From: Habib, Donald
Sent: Wednesday, January 10, 2018 4:10 PM
To: Vogtle PEmails
Subject: Vogtle COLs - Technical Meeting on Shake-Space LAR January 11, 2018
Attachments: Slides to Support LAR 205 Discussion.pdf

This presentation will be discussed at the NRC public meeting with Southern Nuclear Company at 9am on January 11, 2018.

Seismic Gap Changes SNC LAR-18-002 (WEC LAR-205)

Change 1: Seismic Gaps between Nuclear Island and Seismic Category II Buildings

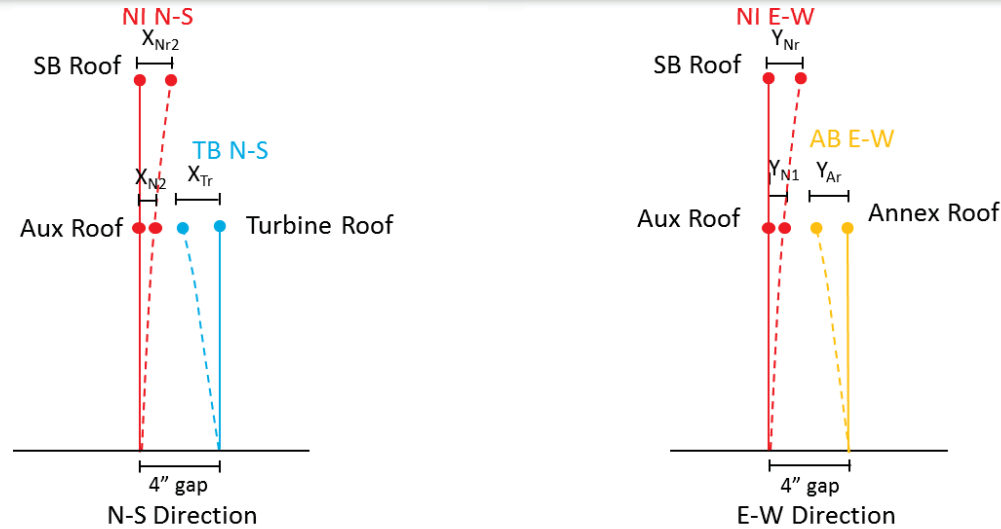
- Current construction requirement: 4" minimum gap between the Nuclear Island (NI) and Turbine Building (TB)/Annex Building (AB) above grade. (Ref. Tier 1 Table 3.3-6, UFSAR Appendix 2.5E Section 5.2 and Subsections 3.7.2.8.1 and 3.8.5.1)
- Current design acceptance criteria: 1" minimum gap during a seismic event. (Ref. UFSAR Subsection 3.8.5.1)
- Current calculations demonstrate margin is greater than the licensing basis design acceptance criteria.

- Challenges with maintaining the minimum 4" gap during construction.
 - NI and TB gap constructed <4" at one localized area.
 - Additional localized exceedances may be identified in future concrete pours.

Note: This LAR does not propose any change to the gap below grade.

Proposed Resolution:

- Reduce the minimum construction requirement from 4" to 3".
- Update calculations to continue to demonstrate the design acceptance criteria (1" minimum gap during seismic event) is met.

Change 2: Seismic Gaps between Nuclear Island and Non-Seismic Buildings

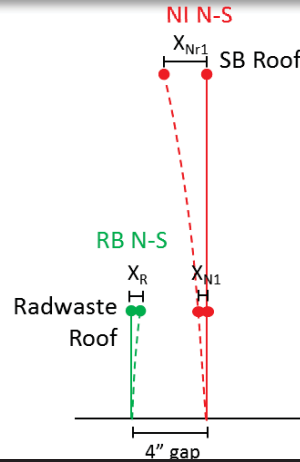
- Current construction requirement: 4" minimum gap between the Nuclear Island (NI) and the Radwaste Building (RB). (Ref. Tier 1 Table 3.3-6 and UFSAR Subsection 3.7.2.8.2)
- Current design acceptance criteria: The RB impact on the NI during a seismic event will not impair its structural integrity. (Ref. UFSAR Subsection 3.7.2.8.2)
- Current calculations demonstrate the design meets licensing basis design acceptance criteria

- The gap between the NI and the RB is not an input to the impact evaluation of RB on NI, therefore it does not affect the acceptance criteria of RB.
 - It is not meaningful to perform the ITAAC inspection on the RB gap when it does not contribute to the design/analysis.

Proposed Resolution:

- Delete the requirement of gap between the RB and NI in Tier 1 Table 3.3-6, item 13.
- Modify UFSAR Subsection 3.7.2.8.2 from a minimum 4" clearance to a nominal 4" clearance.
- Update calculations to continue to demonstrate the design acceptance criteria (no impairment on NI integrity) is met.
